LAFOURCHE PARISH FIRE DISTRICT NO. 3

FIRE CENTRAL TRAINING TOWER CUT OFF, LAFOURCHE PARISH, LOUISIANA

ADDENDUM NO. 1

Date Issued: February 13, 2025

Drawing 19 – Water Line Plan (Overall)

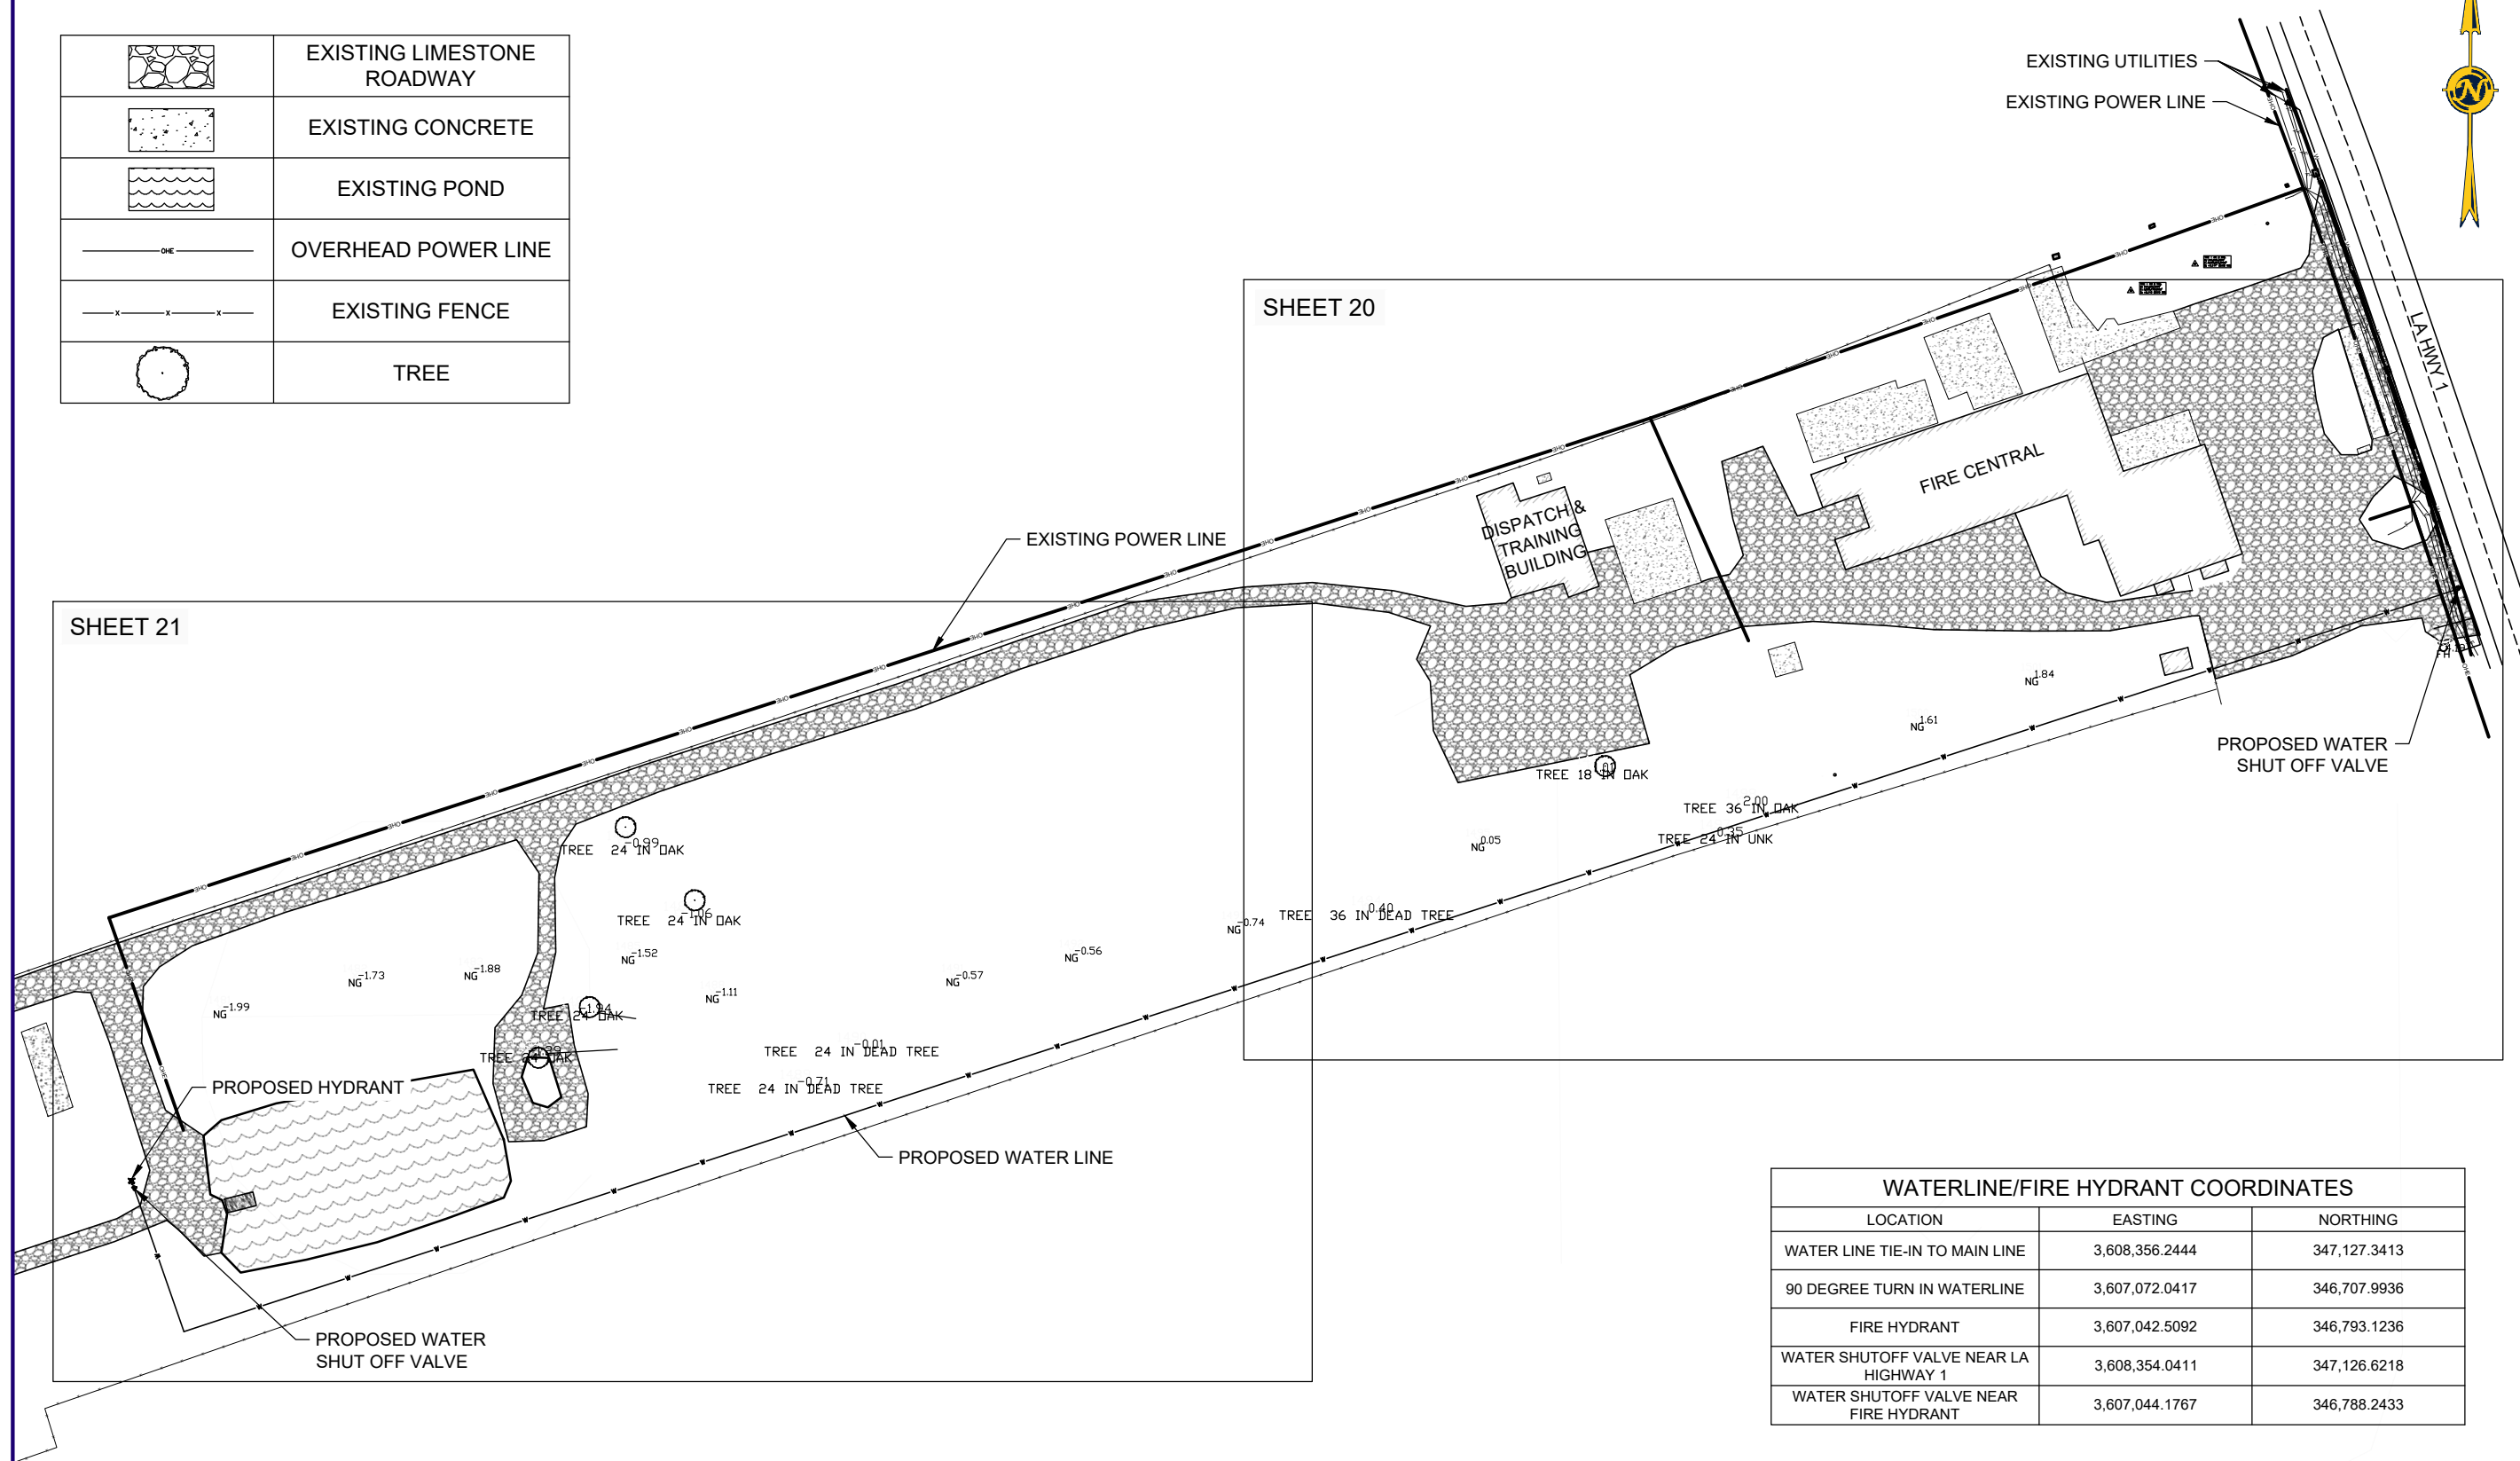
Response: The water line piping has been revised to 8” C-900 Pipe. Please see the revised specifications and drawings regarding this water line included in this addendum.

1. ALL WATER LINE PIPING SHALL BE 8" C-900 PIPE.
2. THE WATER LINE THAT PARALLELS LA HIGHWAY 1 IS BELIEVED TO BE BETWEEN 3.5' AND 4' BELOW THE NATURAL GROUND.
3. TYPICAL WATERLINE TRENCH SECTION CAN BE FOUND ON THE LAFOURCHE PARISH WATER DISTRICT #1 STANDARD PLANS (SHEET 2 OF 2).
4. ALL WATER LINE COMPONENTS, INCLUDING TRENCHING, BACKFILLING, AND BEDDING MATERIAL SHALL BE PAID UNDER ALTERNATE NO. 2.
